Subject: 13 Typo; Pacific Road Palm Beach NSW 2107 DA 2020/1136 WRITTEN
SUBMISSION: LETTER OF OBJECTION Submission: Casey

Re:
13 Pacific Road Palm Beach NSW 2107
DA 2020/1136

WRITTEN SUBMISSION: LETTER OF OBJECTION
Submission: Casey

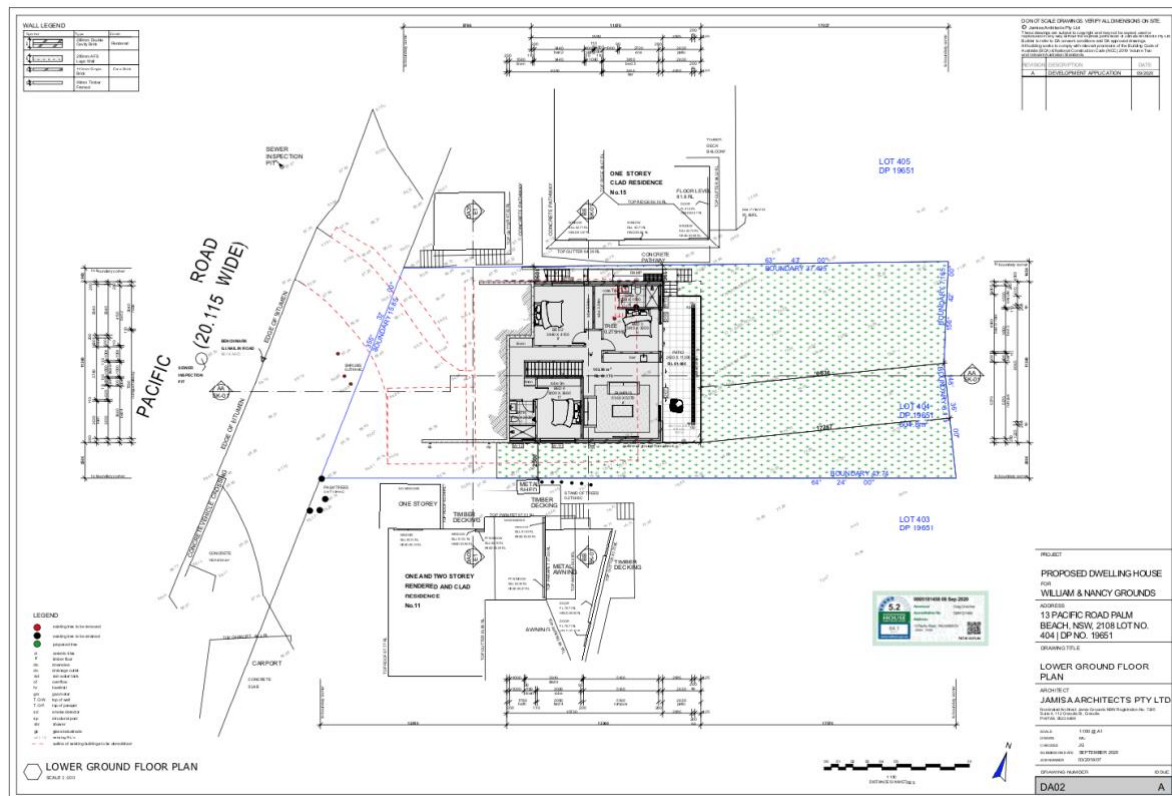
Our property is shown on the attached map 'red starred'. The subject site is shown 'edged in red and flagged'.

FIRST FLOOR PLAN

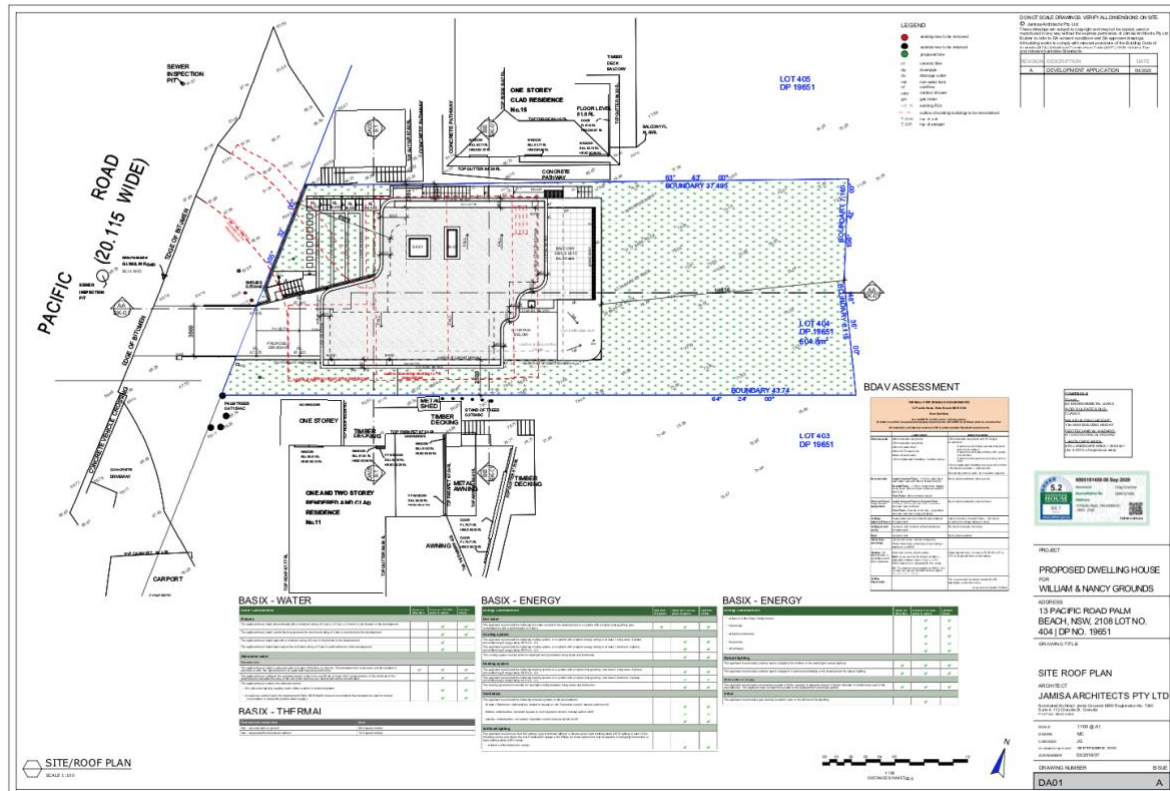
- The south east corner of the proposed first floor shows a proposed balustrade height at RL 88.21. The survey shows the land at RL 76.92. The building height at this location is 11.29m, exceeding controls by 2.79m, a **33% non-compliance**.

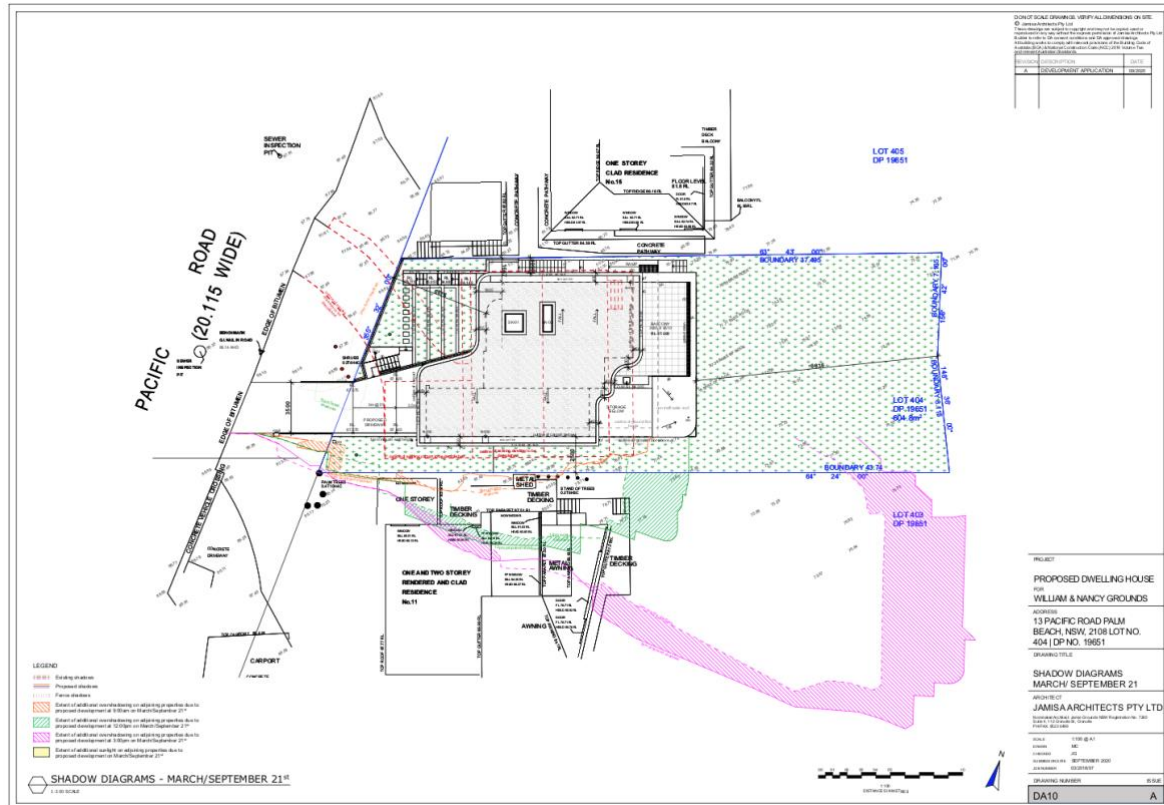
The assessment of the development against the planning principle results in the development not complying with the solar access controls and therefore amended plans should be requested to reduce

The windows in question are our north to north-west facing windows, that provide winter sunshine and daylight into our dwelling, into our highly used Study. What has been submitted gives the very clear indication that the outcome is not in accordance with controls.

the overshadowing impact on the adjoining neighbour. It is suggested that a more skilful design of the development, with a compliant building height, would result in less impact in regard to solar access. It is requested that Council seek amended plans for the development to reduce the impact of the development, and these matters are addressed latter in this Written Submission.

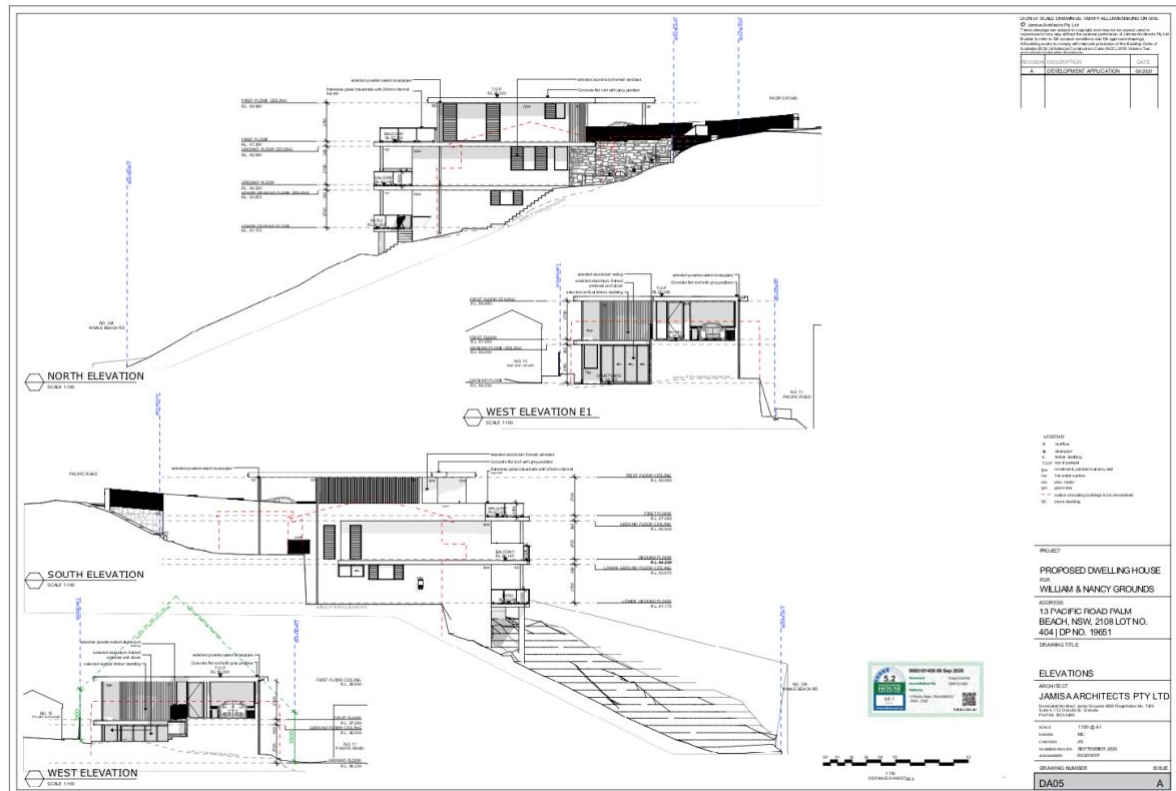
We are concerned to the glazed surfaces facing our property. We ask for these to be completely removed and replaced by windows with 1.6m high sills used in other locations of the proposed development, with privacy screens added.
